3/31/09	Added General Note (F)
DATE	REVISION	
STATE OF HAWAII DEPARTMENT OF TRANSPORTATION HIGHWAYS DIVISION BRIDGE GENERAL NOTES INTERSTATE ROUTE H-1 EXTENSION AND REPAIR OF SCHOOL STREET ON-RAMP RETAINING WALL Project No. H11-01-08 Scale: As Noted Date: Feb., 2009

3/31/09	Revised and/or Added Callouts and Legend
DATE	REVISION
STATE OF HAWAII DEPARTMENT OF TRANSPORTATION HIGHWAYS DIVISION RETAINING WALL REPAIR and EXTENSION EXISTING SITE PLAN INTERSTATE ROUTE H-1 EXTENSION and REPAIR of SCHOOL STREET ON-RAMP RETAINING WALL Project No. H11-01-08	
Scale: As Noted	Date: Feb, 2009
SHEET No. Q3 OF 34 SHEETS

RETAINING WALL REPAIR and EXTENSION

△ LIGHT STANDARD CONCRETE SEAT on WALL "P" at RAMP 7 STA. 10+09
Scale: 1" = 1'-0"

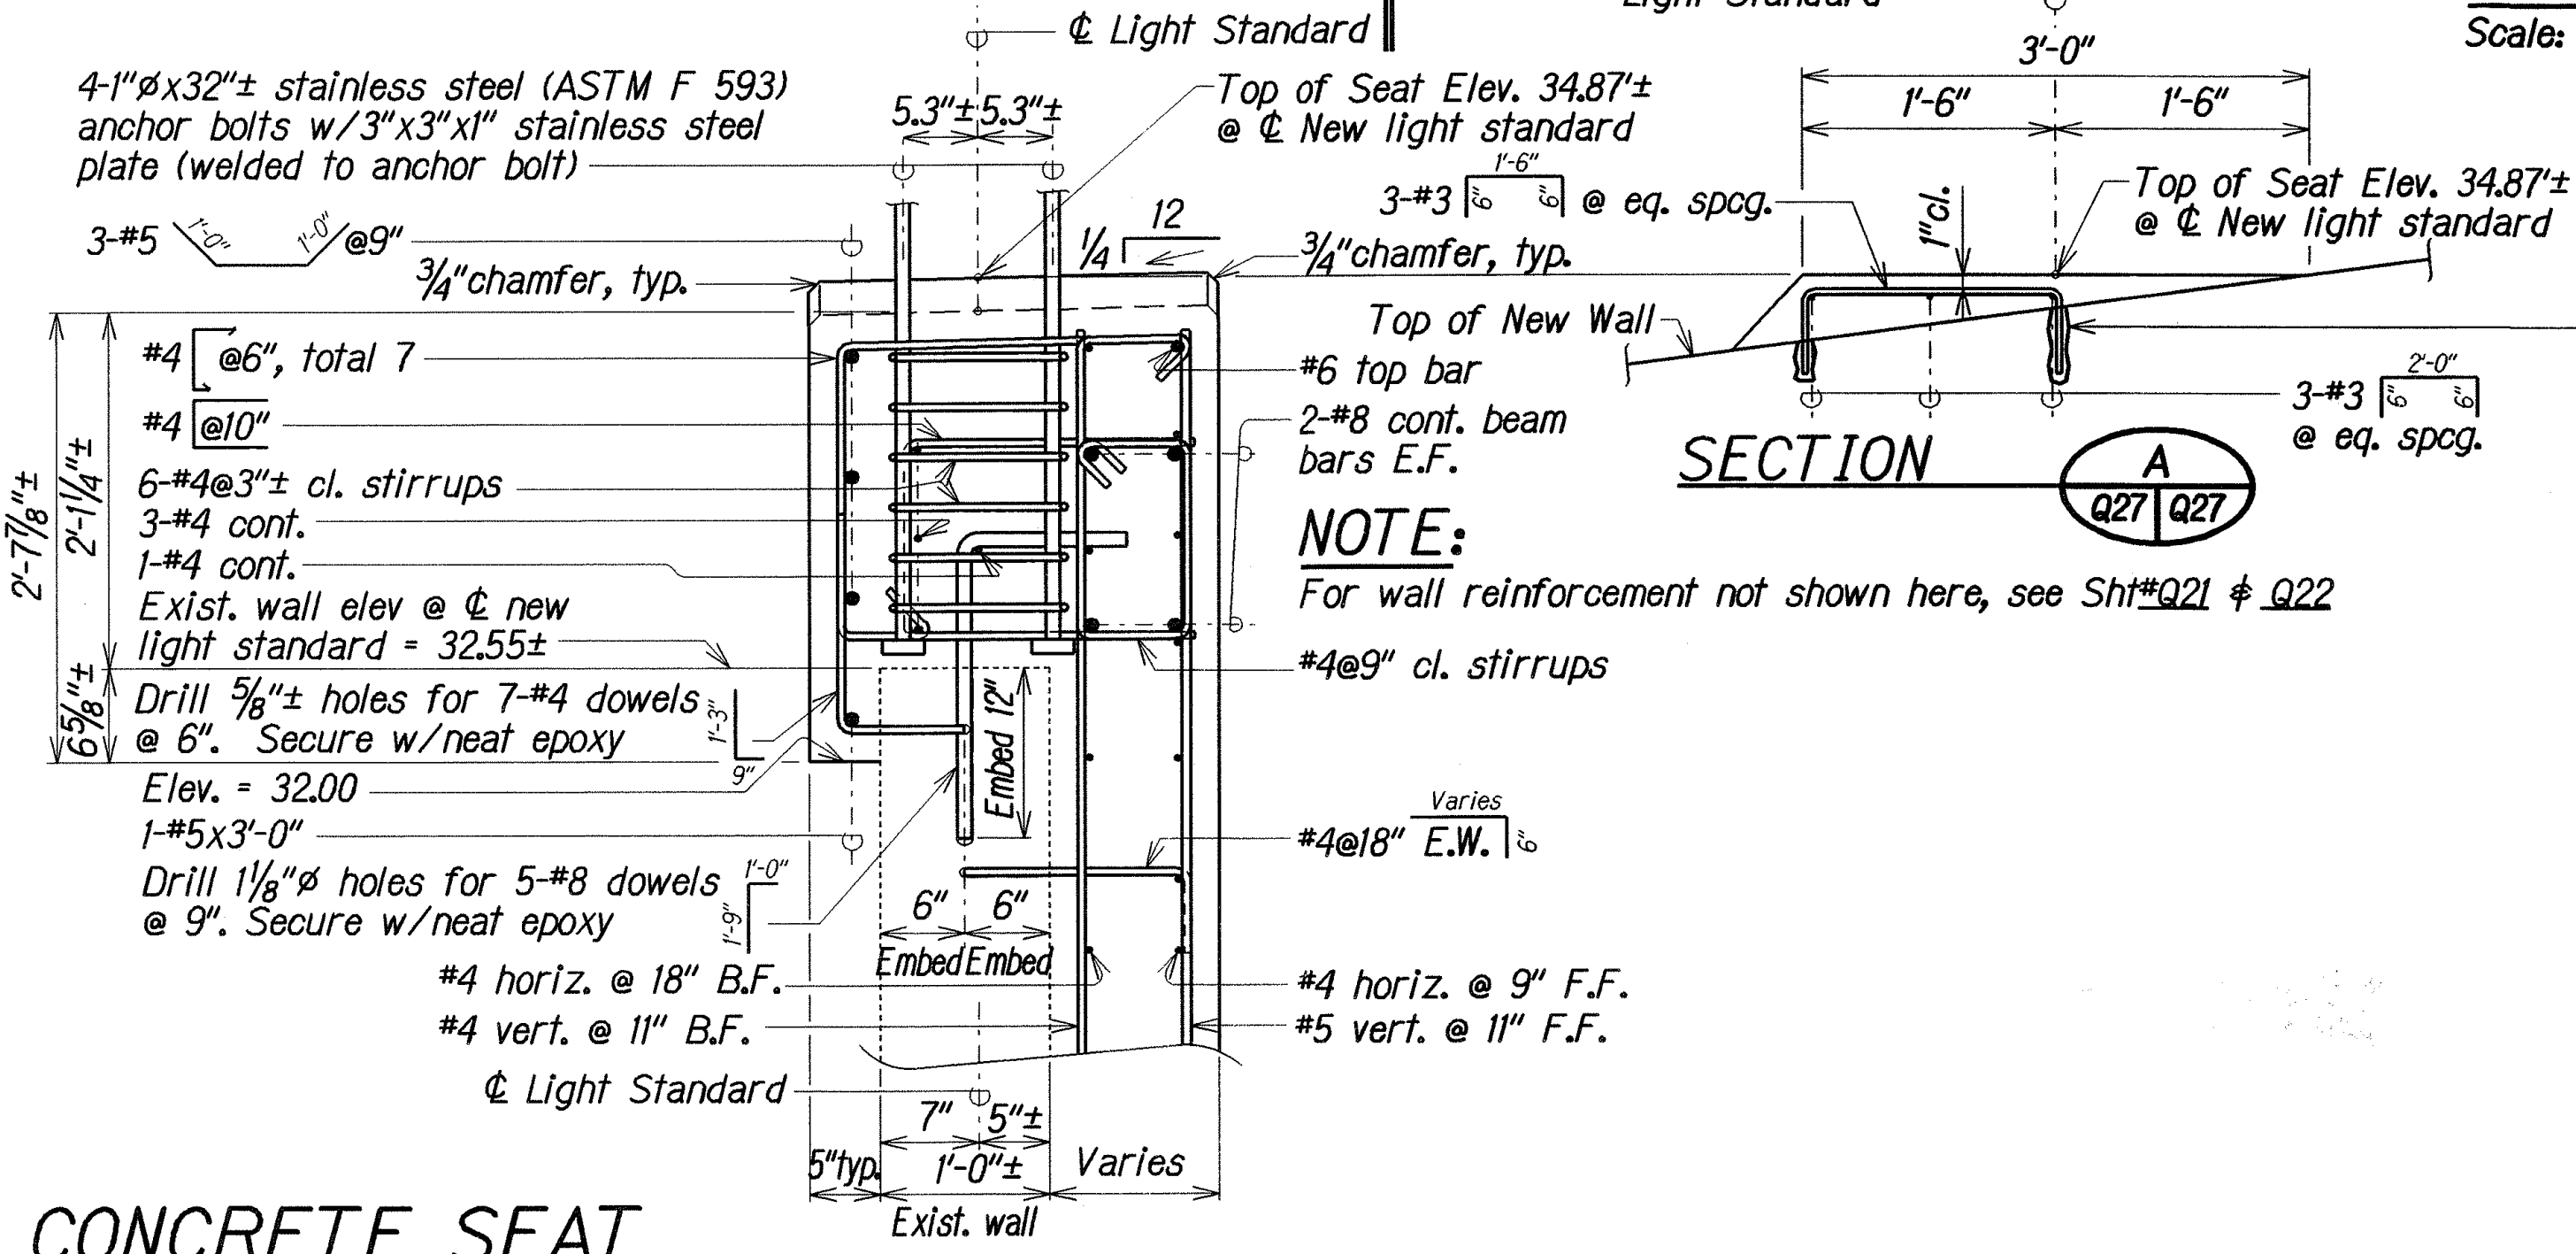
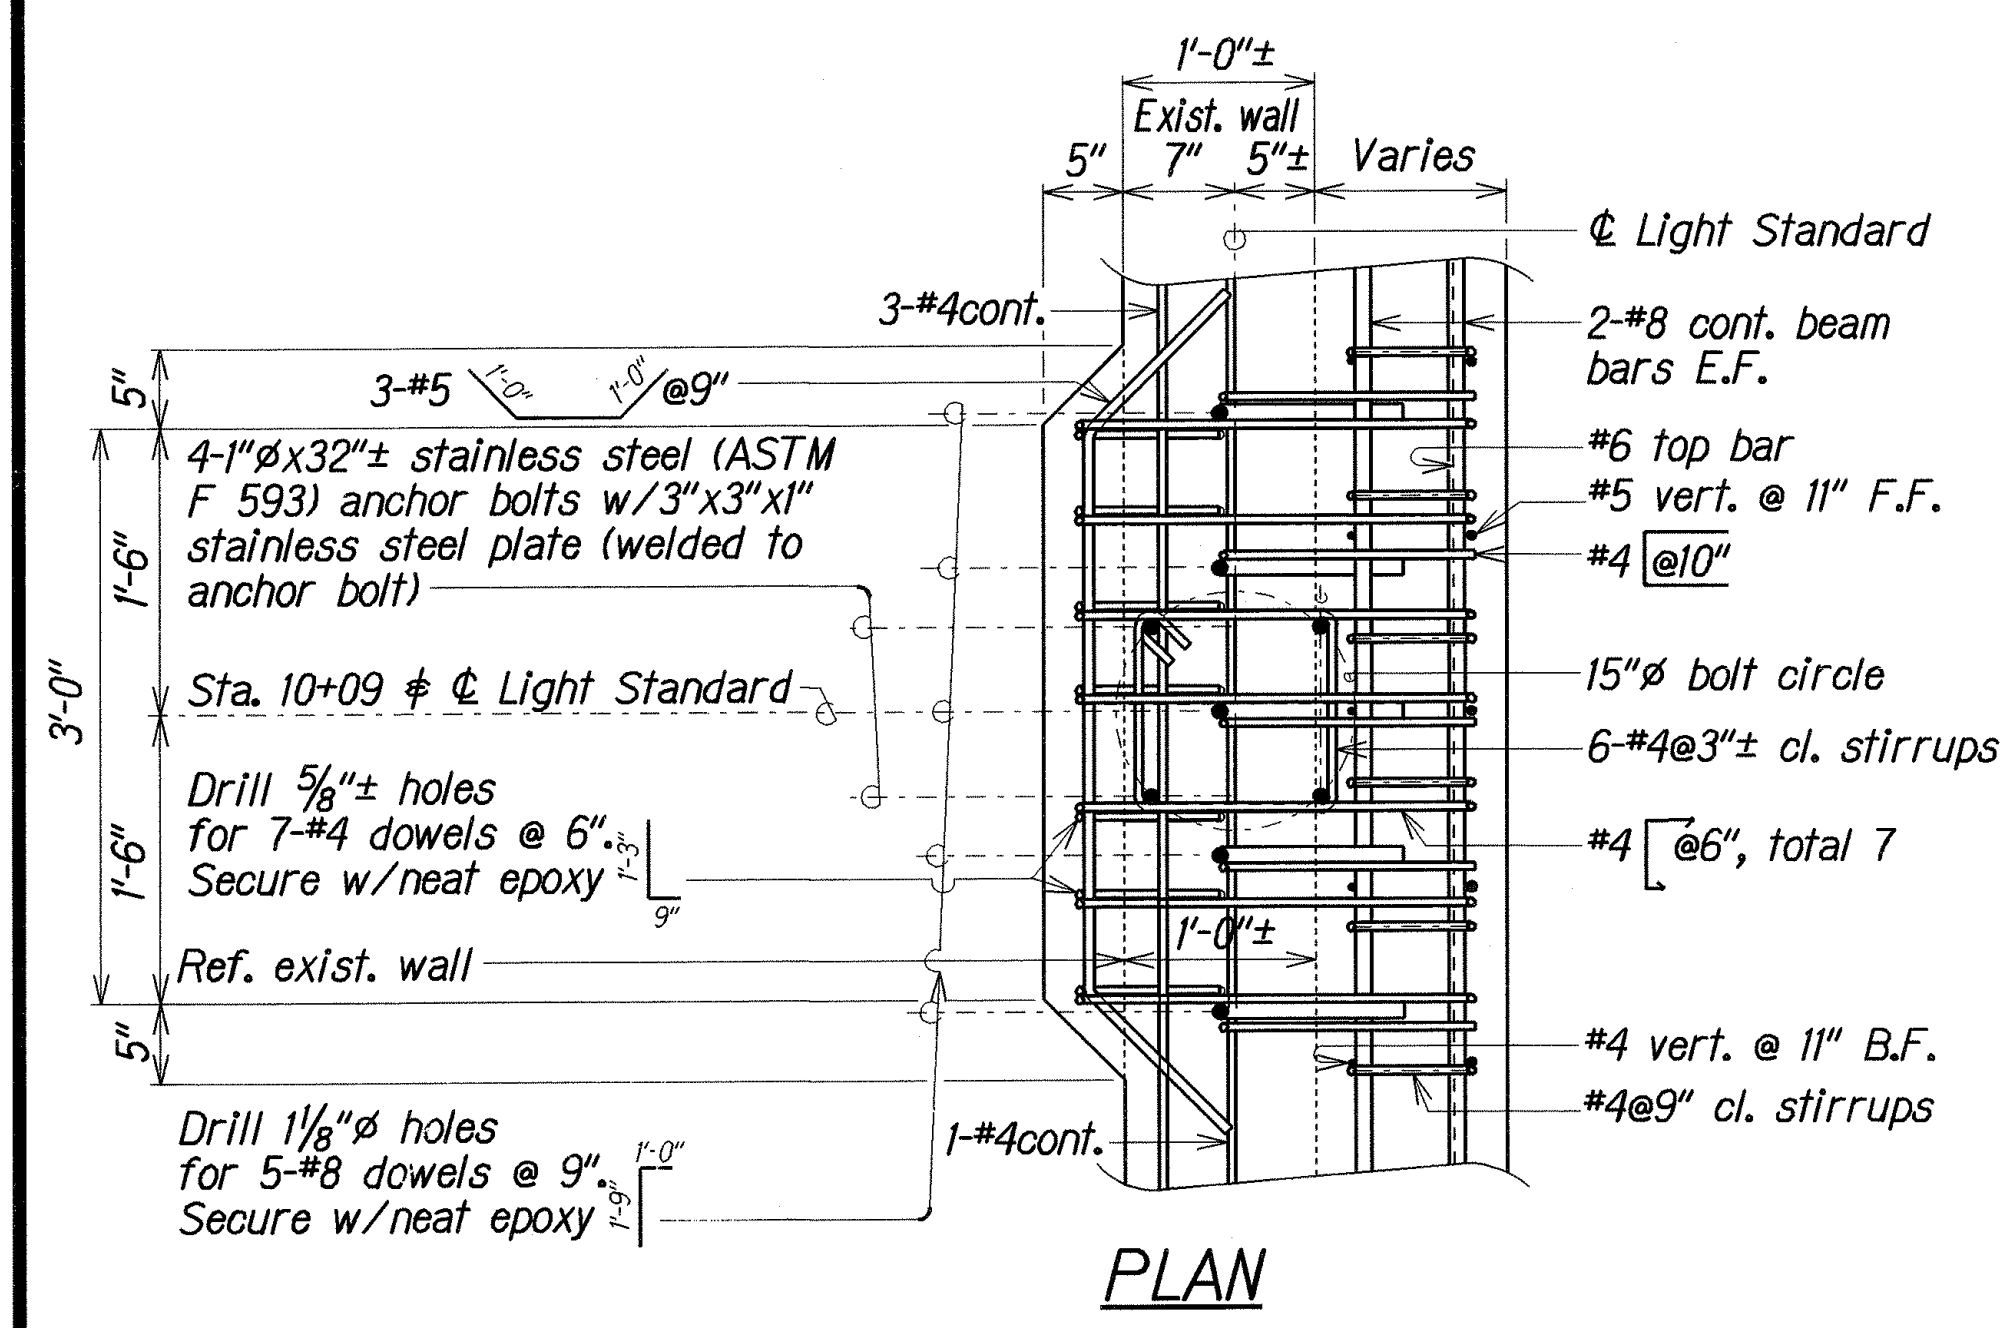
DATE	REVISION
3/31/09	Added Light Standard Concrete Seat on Wall "P" at Ramp 7 Sta. 10+09 Details
STATE OF HAWAII DEPARTMENT OF TRANSPORTATION HIGHWAYS DIVISION RETAINING WALL REPAIR ALTERNATE FOOTING DOWEL PLACEMENT, WEEP HOLE AND LIGHT STD. @ STA. 10+09 DETAILS INTERSTATE ROUTE HI EXTENSION AND REPAIR OF SCHOOL STREET RAMP RETAINING WALL Scale: As Noted Project No. HII-01-08 Date: Feb. 2009	
SHEET No. Q27 OF 34 SHEETS

RETAINING WALL EXTENSION
SCHOOL STREET END POST to LILIHA SEPARATION END POST PLAN and ELEVATION
INTERSTATE ROUTE H-1 EXTENSION and REPAIR of SCHOOL STREET ON RAMP RETAINING WALL
Project No. H11-01-08

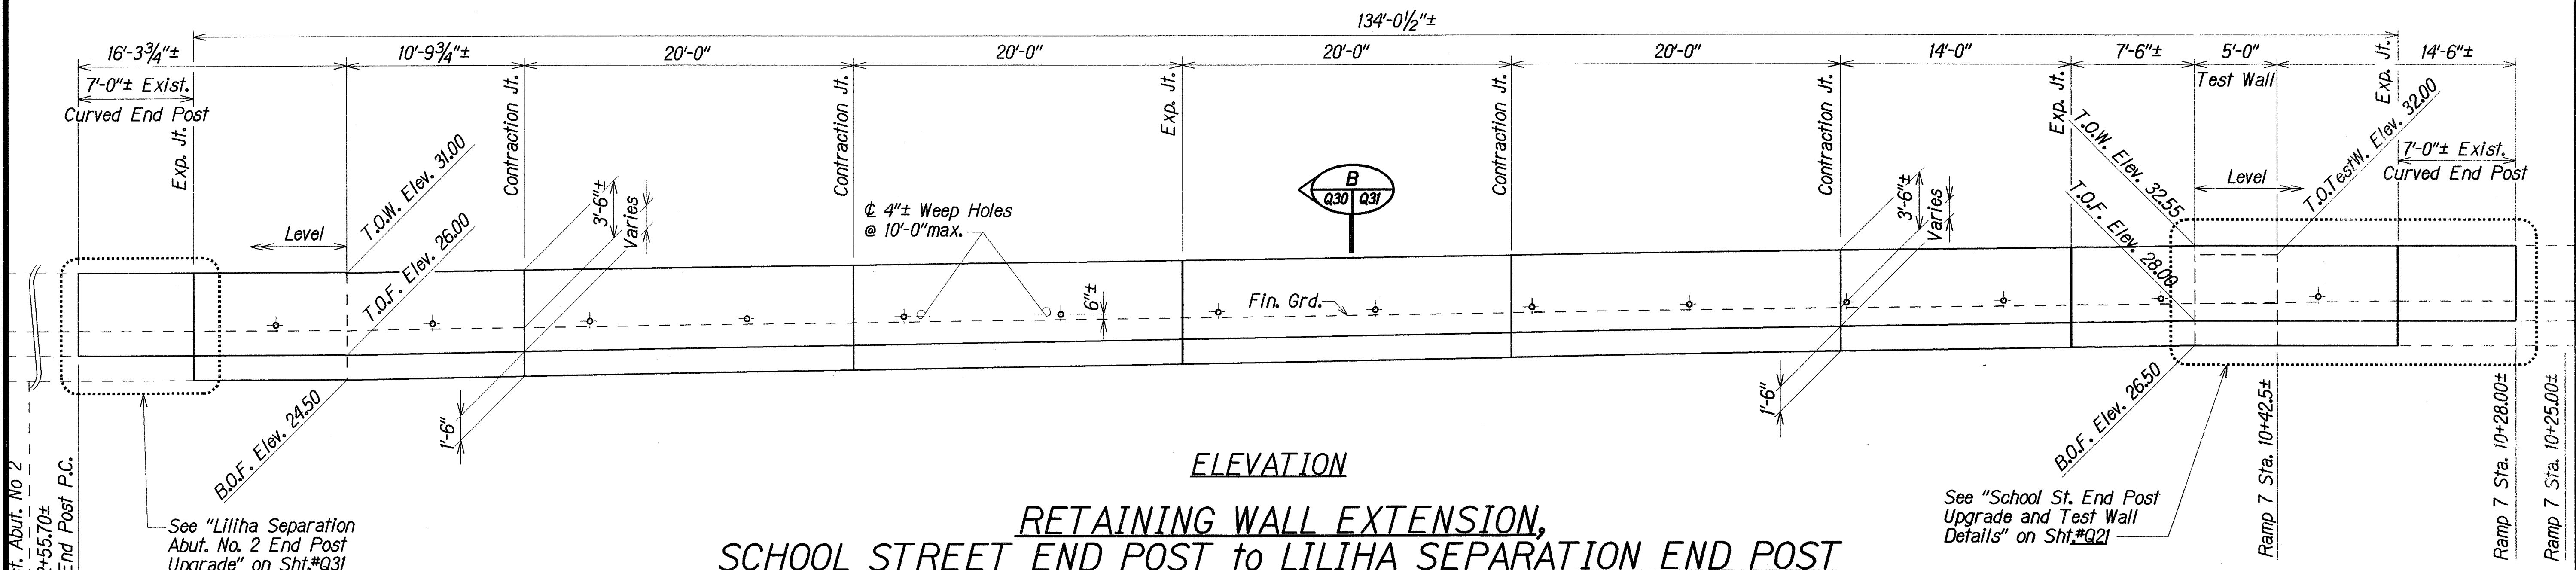
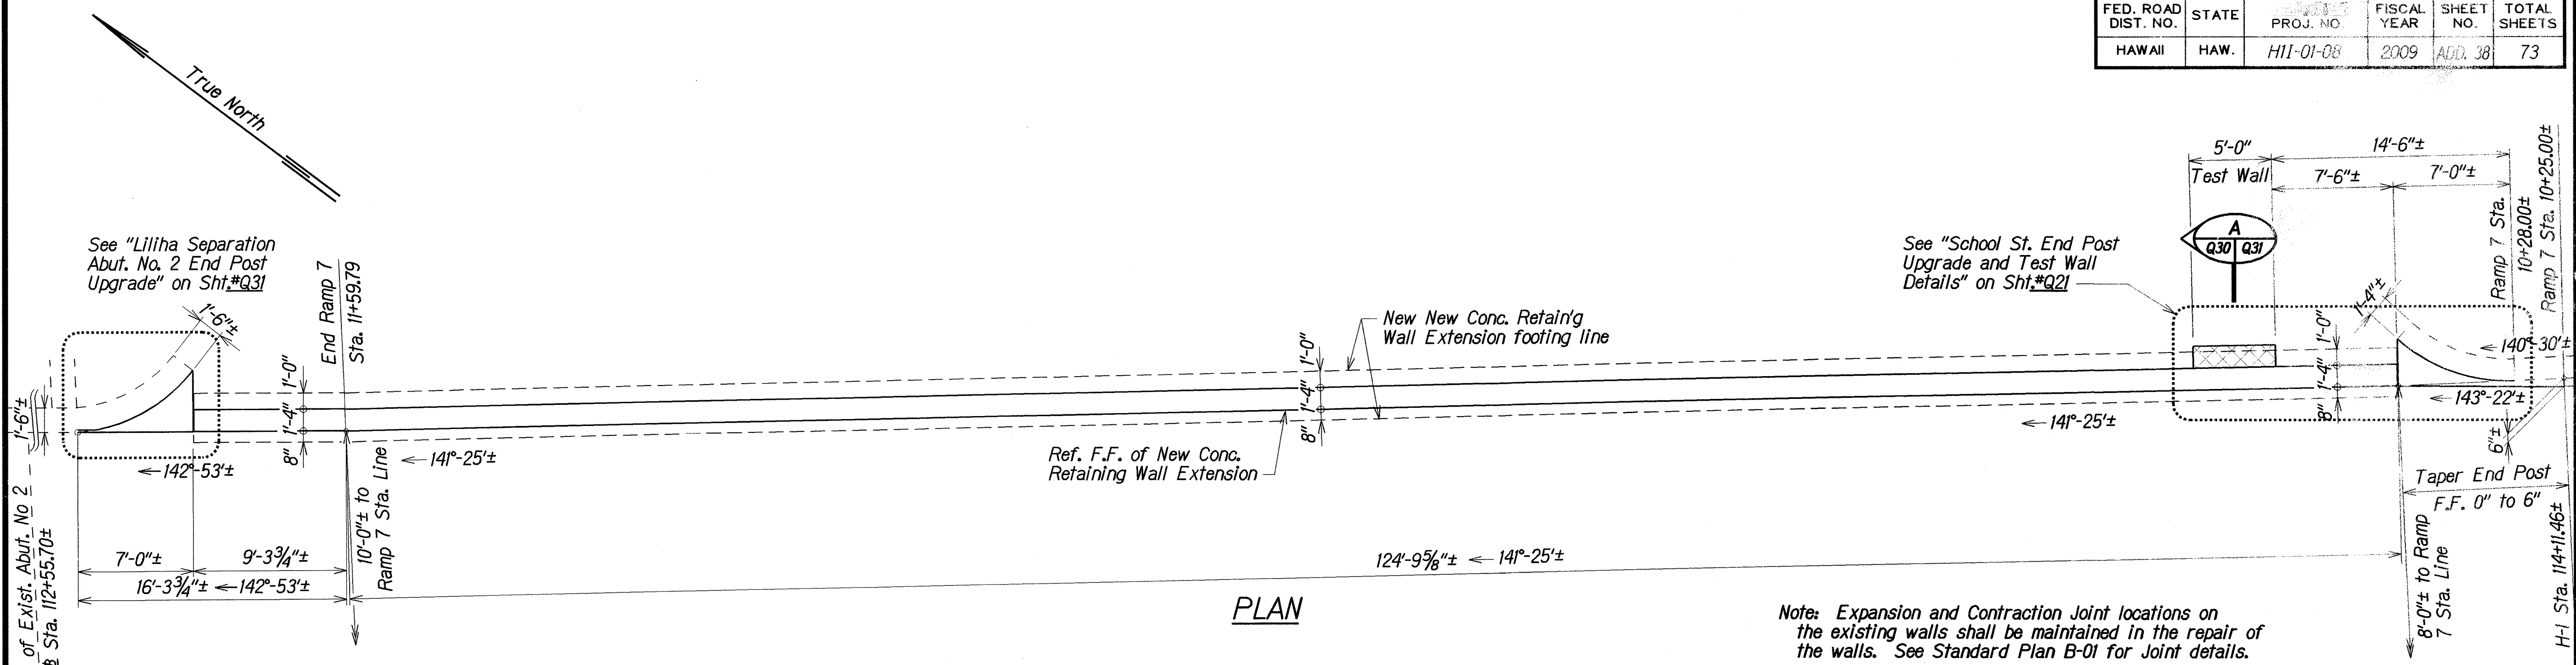
3/31/09	Revised Face of Exist. Abut. No. 2 Station Number
DATE	REVISION
